# **Intel<sup>®</sup> Pentium<sup>®</sup> III Xeon<sup>™</sup> Processor Specification Update**

Release Date: December 2000

Order Number: 244460-023

The Pentium<sup>®</sup> III Xeon processor may contain design defects or errors known as errata that may cause the product to deviate from published specifications. Current characterized errata are documented in this Specification Update.

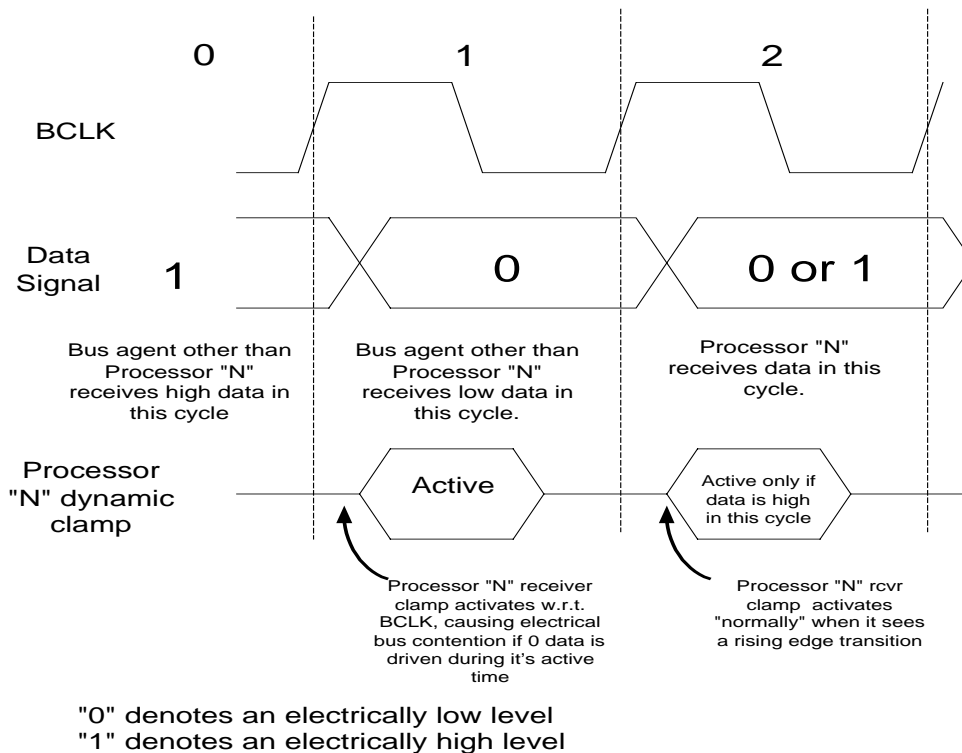
**Workaround:** The AGTL+  $V_{REF}$  (input voltage reference) level will be raised from 1.0V to 1.1V (assuming a  $V_{TT}$  of 1.5V) on the processor cartridge substrate. This allows the dynamic clamp to activate at a trigger level approximately 100 mV higher than with the previous 1.0V  $V_{REF}$  setting. Due to the dependence upon system bus design, bus layout may be evaluated to determine the need for improvements in falling edge ringback levels. This may involve one or several of the following baseboard modifications:

1. Change termination resistor value to reduce multi-bit noise and/or improve  $V_{IL}$  noise margin.
2. Reduce multi-bit noise by improving ground return paths (additional high-frequency decoupling, improved AC plane referencing, etc.).
3. Raising or lowering the  $V_{TT}$  level (within the AC & DC tolerances specified in the processor EMTS) to improve  $V_{IL}$  noise margin and/or reduce the multi-bit noise due to  $dl/dt$  transients.

Stress tests using various data patterns and transactions should be run to identify the worst-case multi-bit noise conditions for this erratum.
